RE: **MCT Frontage Road Property
Grading and Drainage Plan
Engineer's Stamp Date 7-21-16 (File:E17D060)**

GRADING & DRAINAGE PLAN

Re: MCT Frontage Road Property
Revised Engineers stamp date 7-26-2016- (EI7D060)

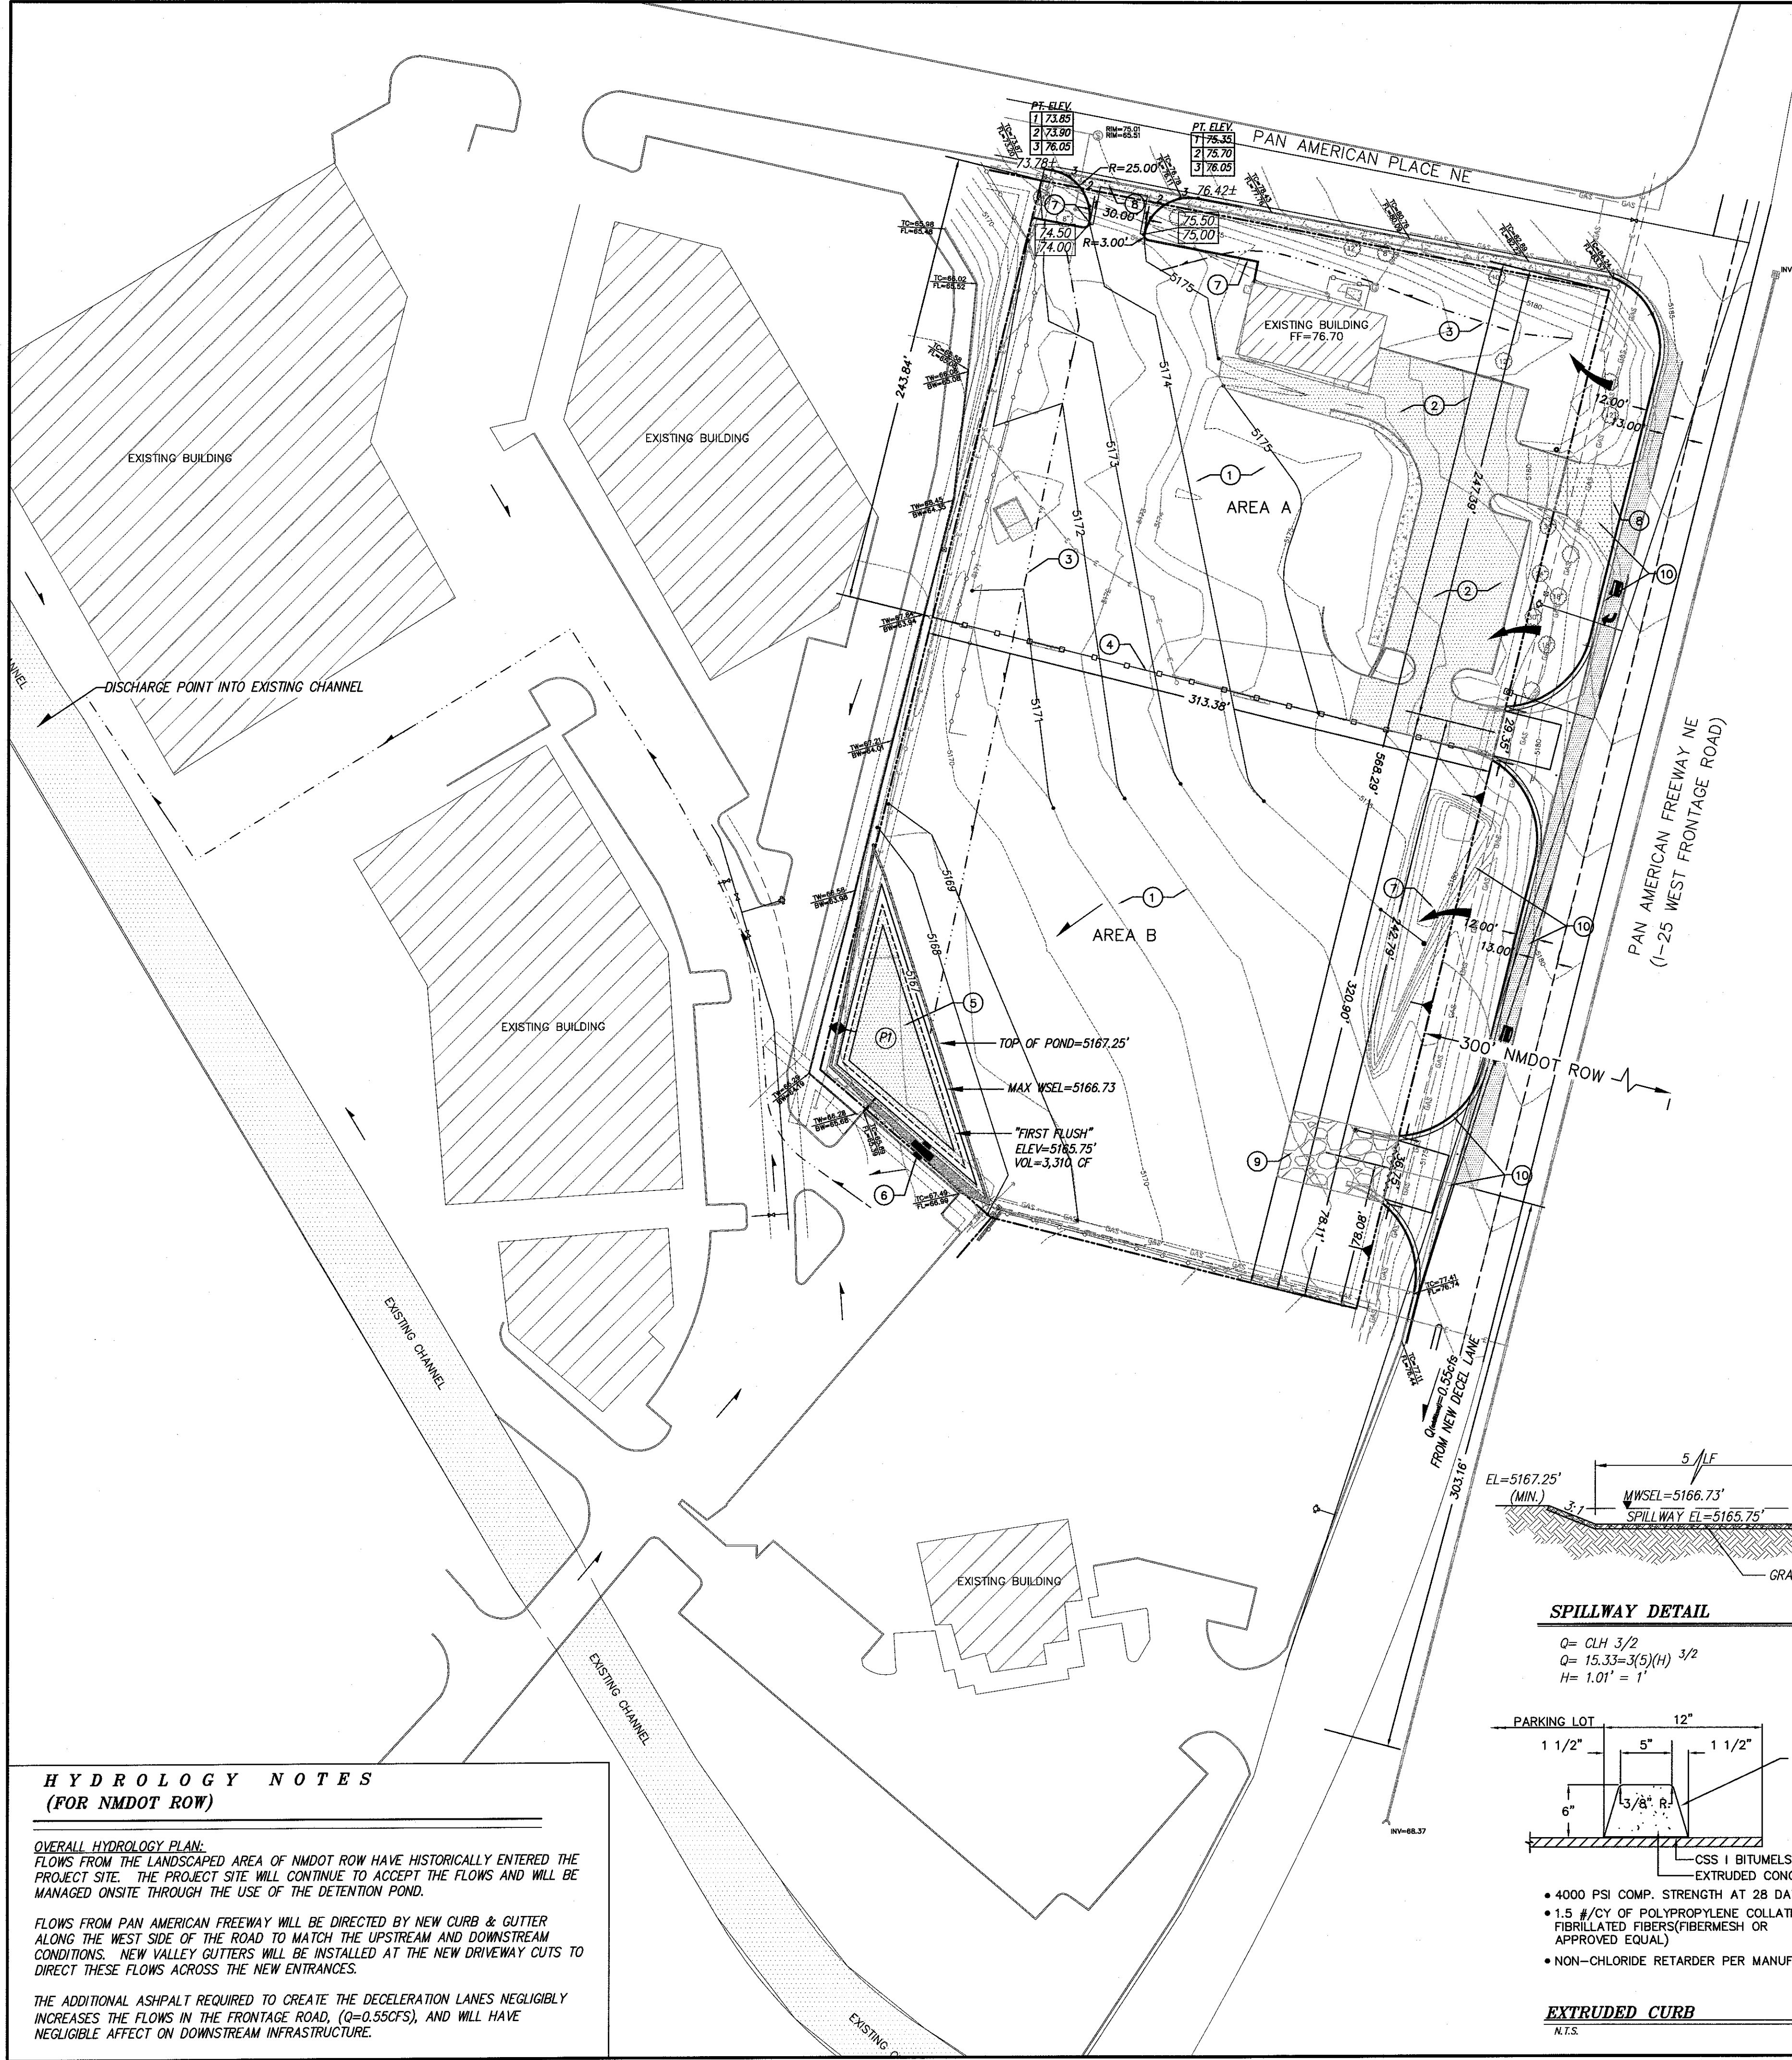
1. **The plan proposes to discharge into the adjacent property to the southwest....."**
In absence of a full drainage report for the adjacent property, we looked at existing and historical conditions. I attached aerial photographs to this letter to show the property from 1996 and 1999. These photographs were taken from Google Earth and the RGIS ortho photography. From these photographs, it is determined that the drainage paths for the area are consistent with the assumptions on the projects site's drainage plan. In addition, there are "offsite" flows from the NMDOT ROW on the east boundary that enter the site. To calculate the historic flows, I inserted the pictures into AutoCAD to get area calculations for the different land treatment types and used AHYMO to determine the flows. The historic flows are summarized on the revised plan and include the offsite flows from the NMDOT ROW.

- a. **"Check the assumptions for the Proposed Conditions..."** The higher assumed impervious area for the proposed conditions is reflective of the use for Area "B". This area will store mini storage sheds on the property that will be for sale to the public. It is assumed that at the highest inventory level, Area B will be 80% impervious.

2. **"...Make sure you have an approved ESC Plan."** The ESC Plan has been submitted for review.
3. **"A approval will need concurrence from NMDOT for improvements on the frontage road."** Construction Plans are being submitted to NMDOT for approval.

4. **"...Lot A and Lot B..."** These areas have been renamed to Area A and Area B for clarification. The site is one (1) property and will not require a cross-lot drainage easement.
